**CERTIFICATE OF APPROPRIATENESS**

**Property:** 625 Cortlandt Street, lot 6, tracts 5 & 7A, block 278, Houston Heights Subdivision. The property includes a historic 1,649 square foot, one-story wood frame single-family residence and a detached garage situated on a 10,560 square foot (80' x 132') interior lot.

**Proposal:** Alteration – Add two dormers, one at the front elevation and one at the rear elevation.  
See enclosed application materials and detailed project description on p. 5-13 for further details.

**Recommendation:** Partial Approval: Approval of the rear dormer; Denial of the front dormer

**ROOF PLAN**  
**EXISTING**

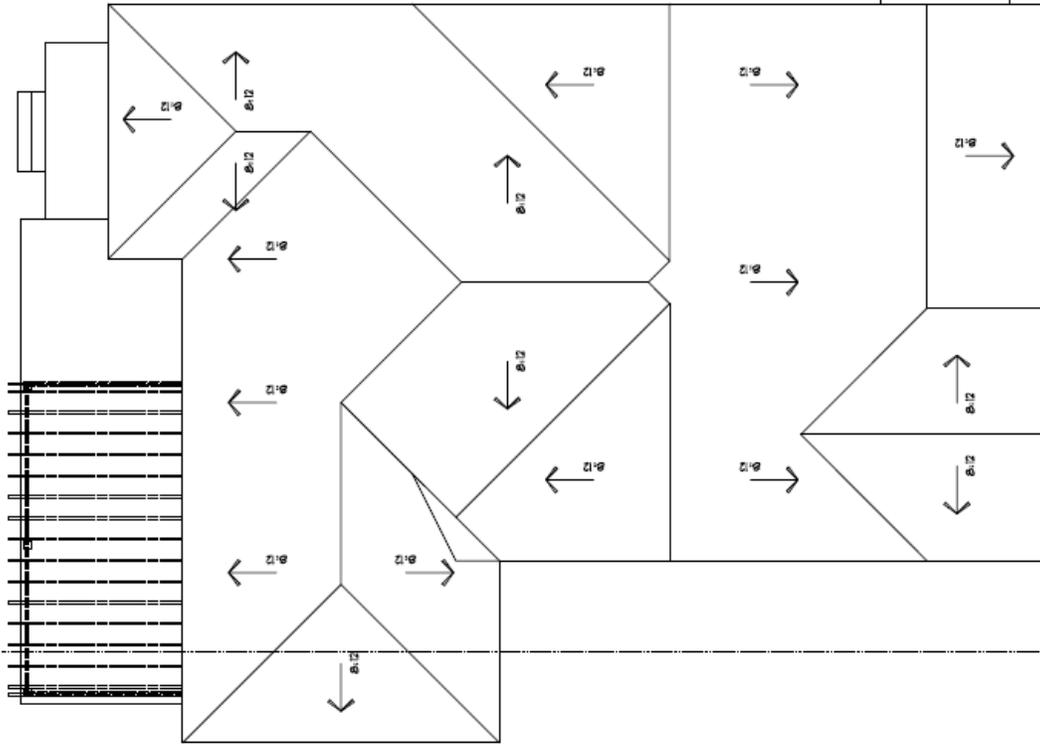
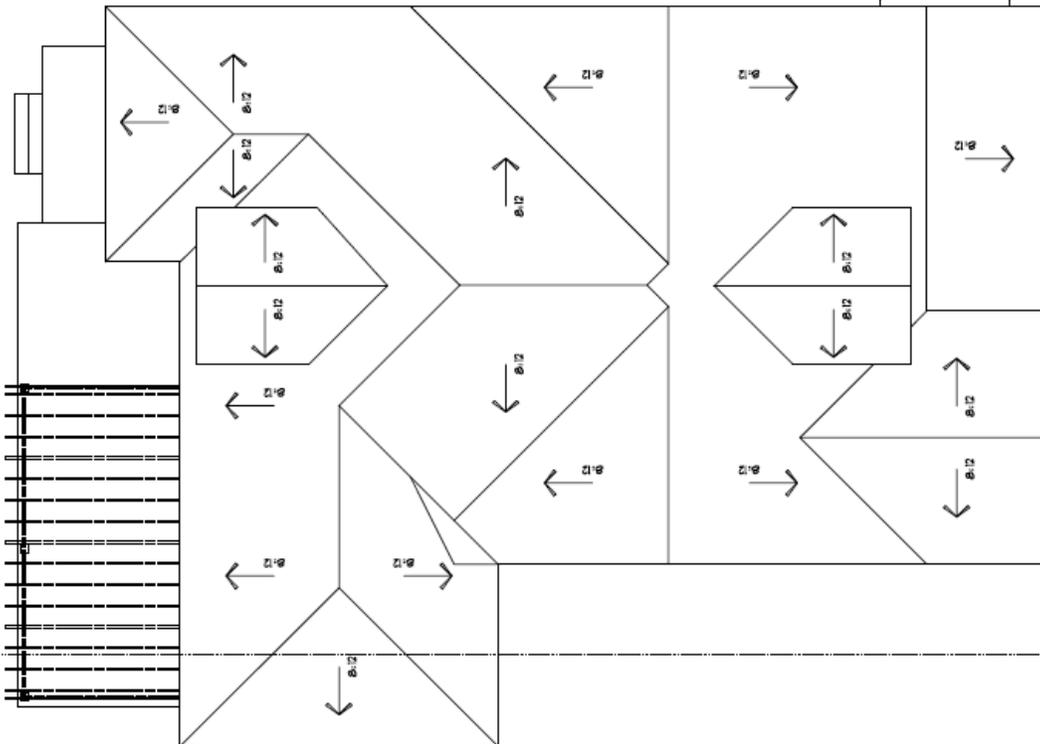
|                                     | <input checked="" type="checkbox"/> | <input type="checkbox"/>            | (1) The proposed activity must retain and preserve the historical character of the property;<br><i>Adding a central dormer to the front of the structure significantly alters its character and becomes a visually dominant feature. An attic build-out is an appropriate and minimally impactful option to increase space, but a less prominent method of providing the space provided by the front dormer should be used.</i>  |
| <input type="checkbox"/>            | <input checked="" type="checkbox"/> | <input type="checkbox"/>            | (4) The proposed activity must preserve the distinguishing qualities or character of the building, structure, object or site and its environment;<br><i>The proposed front dormer alters rather than preserves the historic character of the unembellished roof form.</i>  |
| <input type="checkbox"/>            | <input checked="" type="checkbox"/> | <input type="checkbox"/>            | (7) The proposed replacement of missing exterior features, if any, should be based on an accurate duplication of features, substantiated by available historical, physical or pictorial evidence, where that evidence is available, rather than on conjectural designs or the availability of different architectural elements from other structures;<br><i>No evidence has been provided suggesting that the structure ever featured a prominent front dormer. The proposed alteration is entirely conjectural.</i> |

**HAHC Action:** Partially Approved: Approval of the rear dormer; Denial of the front dormer
